Building Permit Application

Permit No.: B14003663

Building Address: 15229 Sweetbay St.
 City: WOODBINE State: MD Zip Code: 21797
 Suite/Apt. # _____ SDP/WP/BA #: F-07-38
 Census Tract: _____ Subdivision: BELLE HAVEN
 Section: _____ Area: _____ Lot: 41
 Tax Map: _____ Parcel: _____ Grid: _____
 Zoning: _____ Map Coordinates: _____ Lot Size: _____

RE: Belle Haven Estates
lot 41 B14003663
5229 ~~1827~~ SWEETBAY STREET
WOODBINE MD. 21797

**SITE PLAN FOR
BAT INSTALLATION**

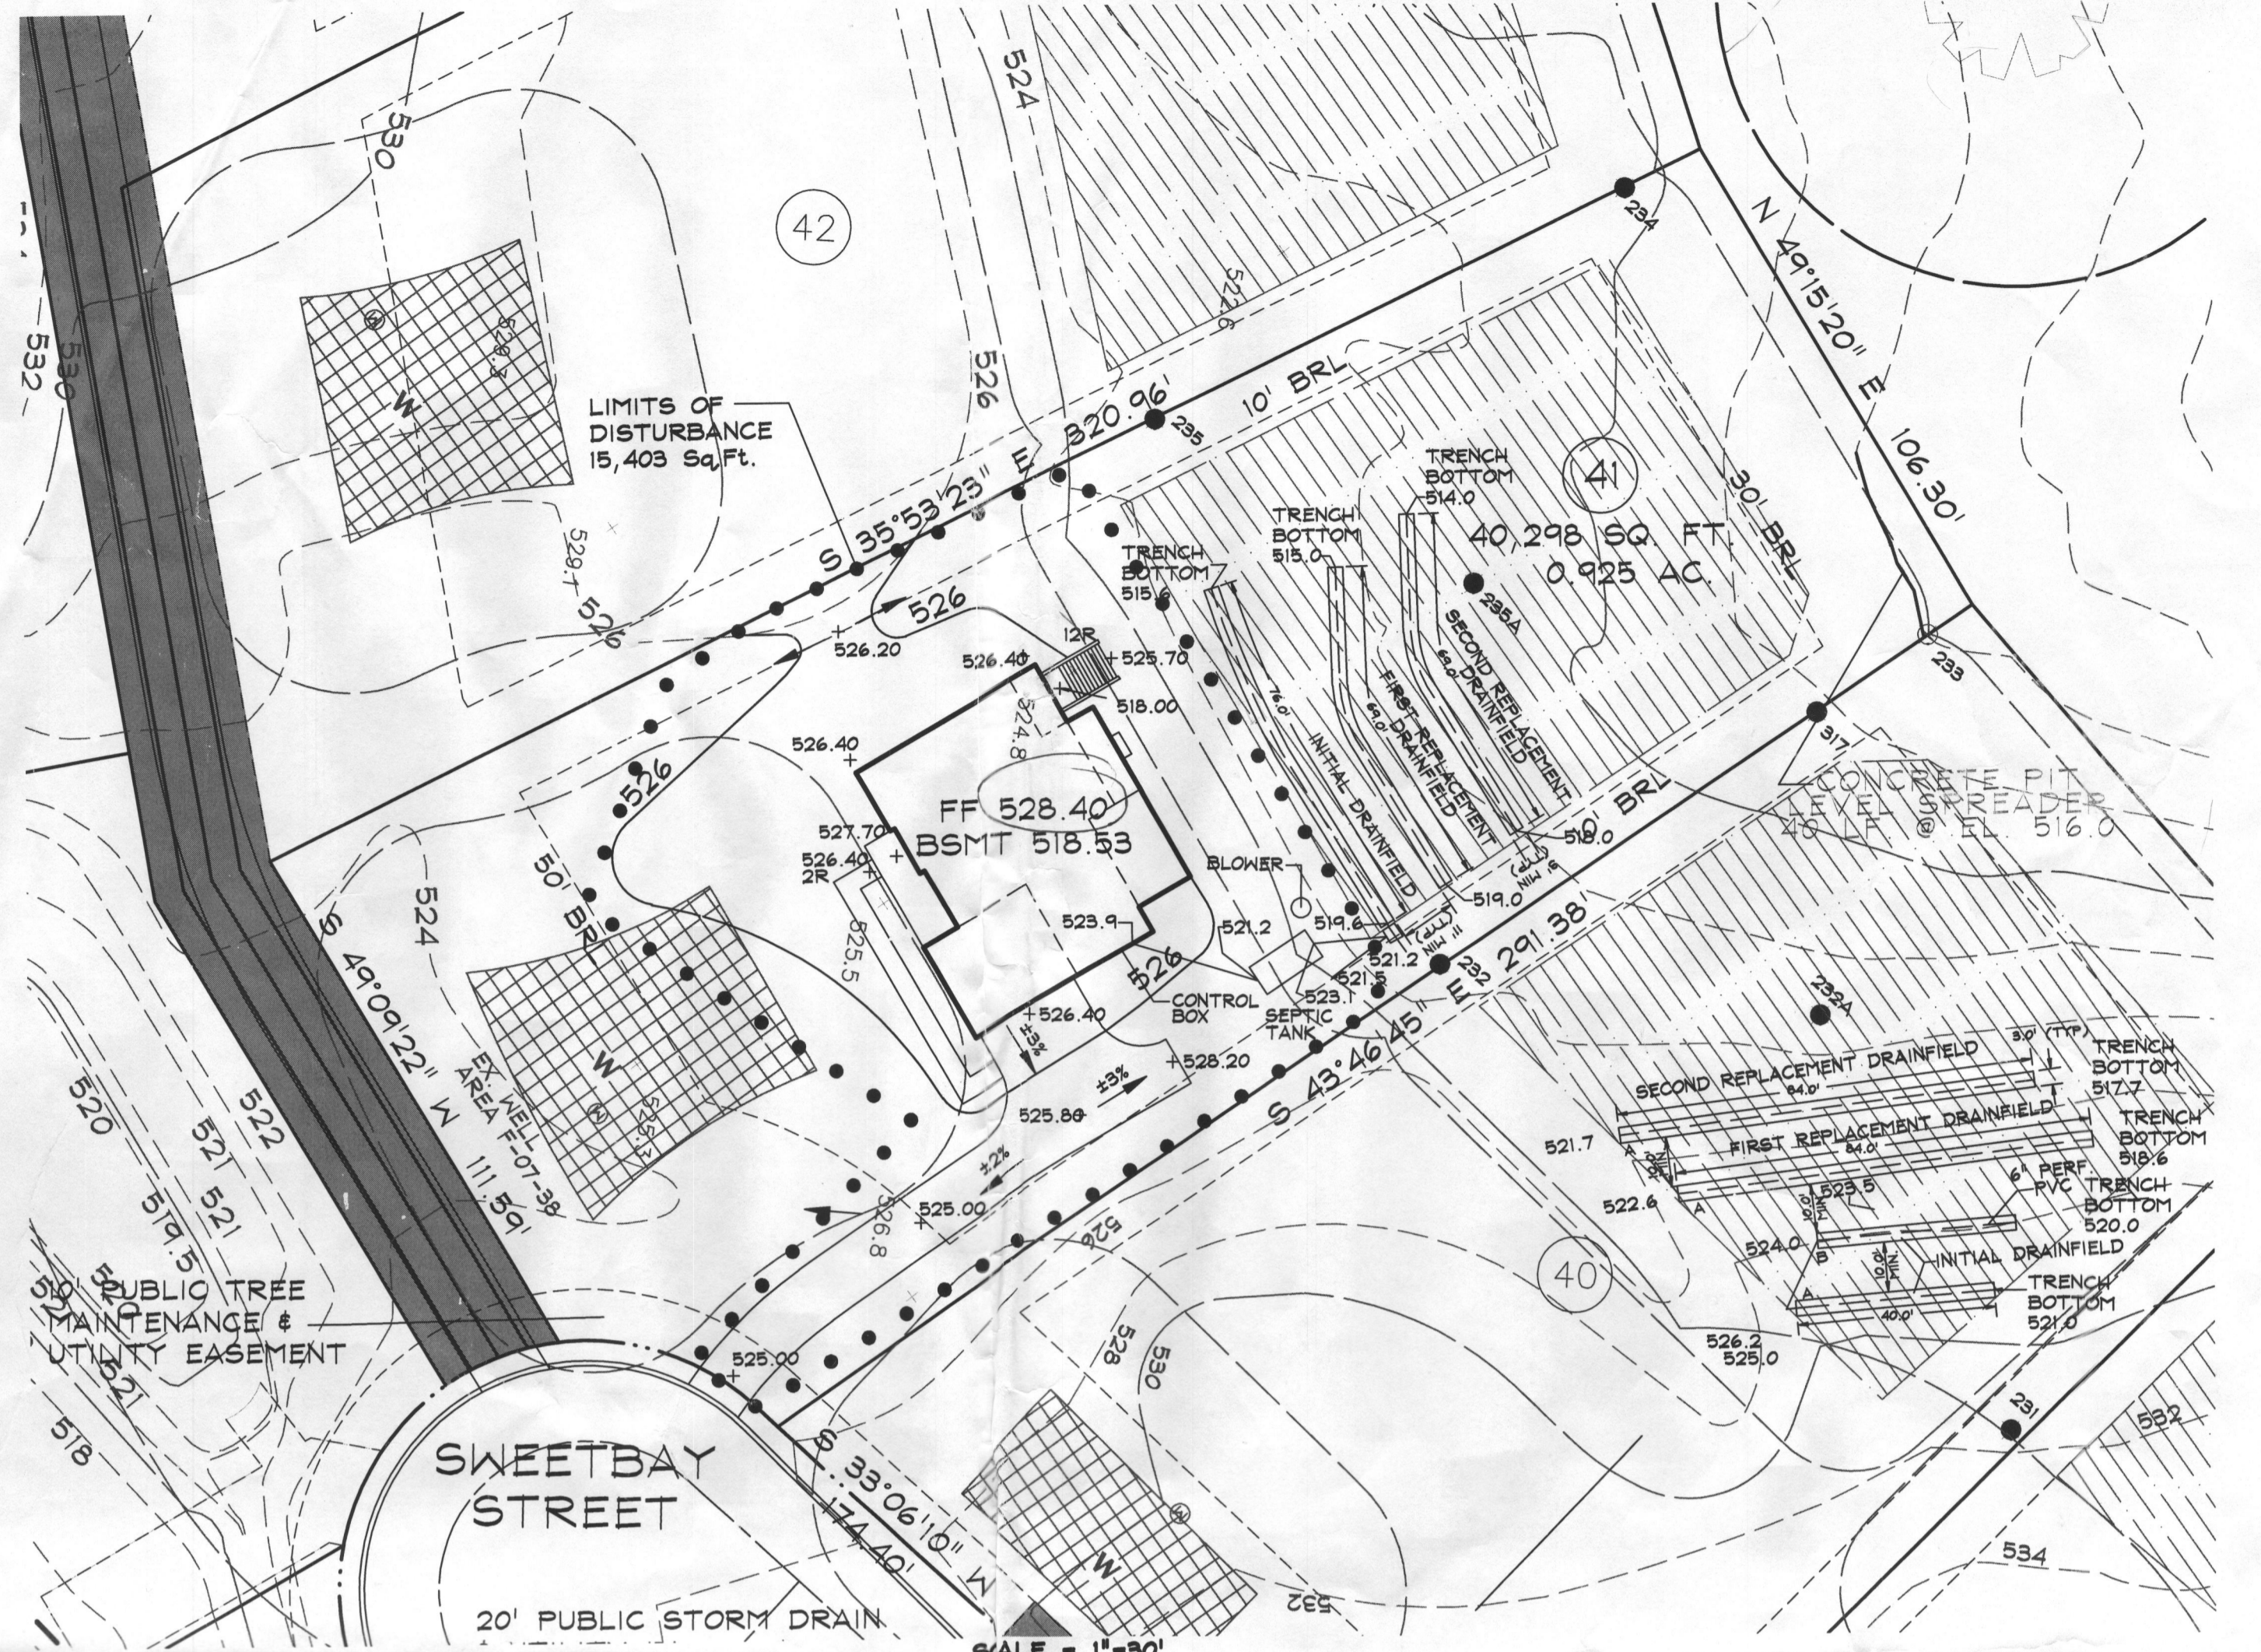
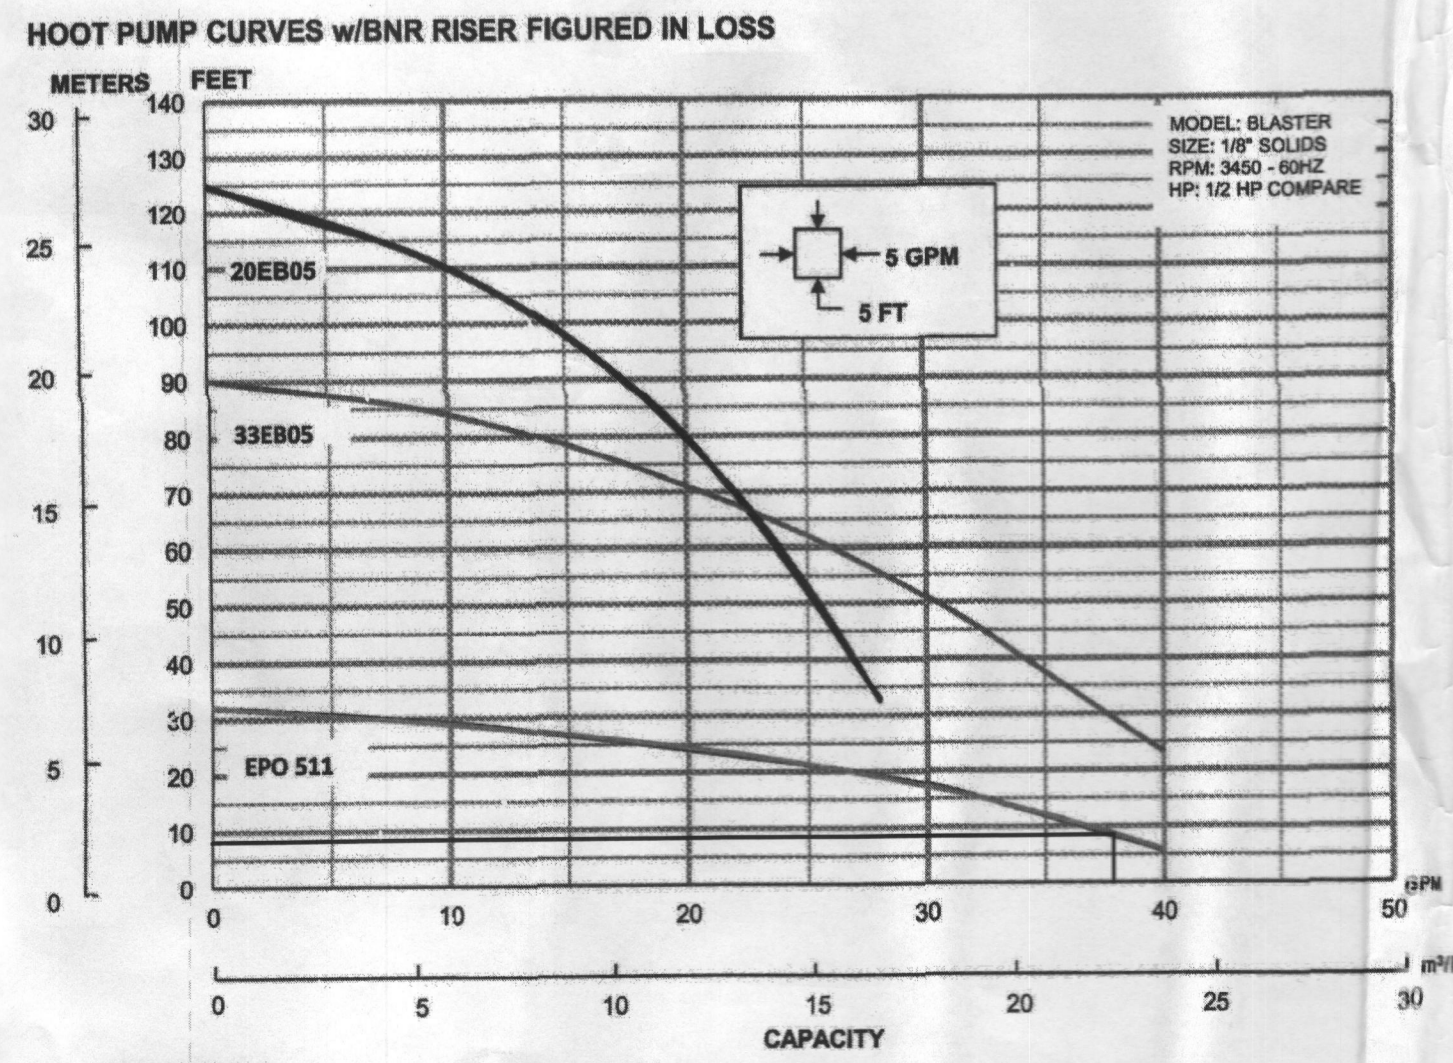
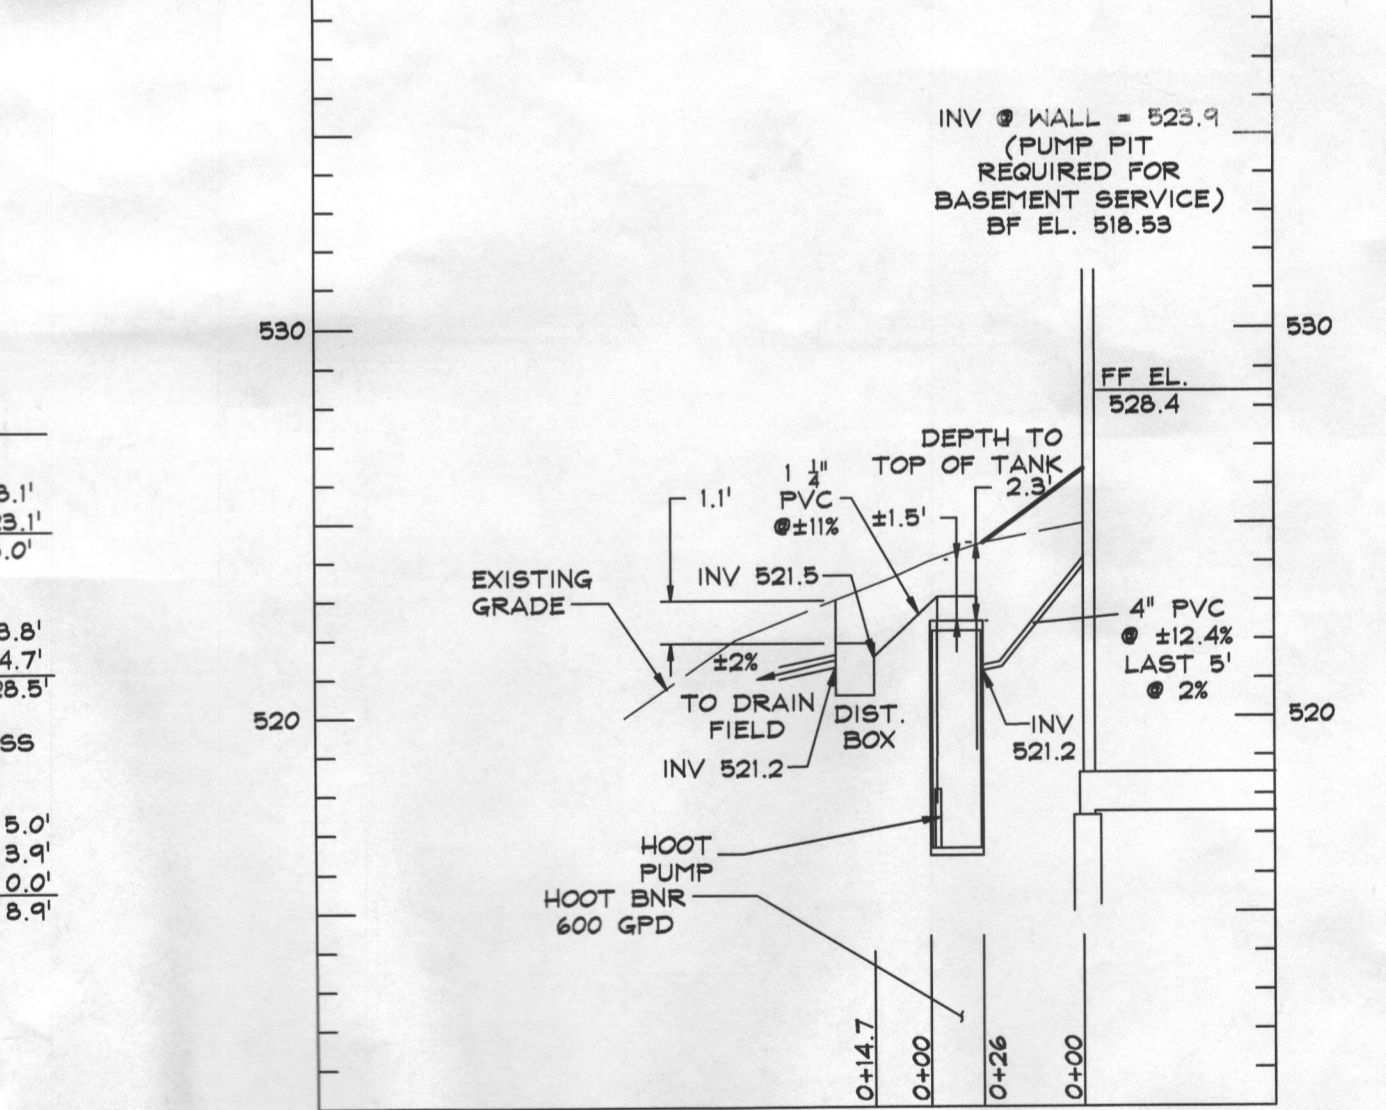
Building permit B14003663 cannot be approved at this time because you still have 5 bedrooms. Even though your basement is not finished you will still have the ability to create five bedrooms because the full bathroom is attached to the den/bedroom. The den/bedroom can be transformed into a bedroom with drywall. Please make adjustments and resubmit. If you would like to have the permit approved as is. We must submit a revised building plan to the department of planning and zoning and to the Howard County health department stating the septic system is designed for a 4 bedroom house and if the homeowner decides to upgrade the unfinished den/bedroom in the basement the septic system must be upgraded. If you have any questions don't hesitate to give me a call.

23. AT ANY TIME IN THE FUTURE THAT A BUILDING PERMIT IS SUBMITTED TO FINISH THE AREA CURRENTLY IDENTIFIED AS OPTIONAL DEN, THEN A SEPTIC SYSTEM UPGRADE WILL BE REQUIRED AS FINISHING THE OPTIONAL DEN CREATES A FIFTH BEDROOM PER HOWARD COUNTY CODE 3.801(B).
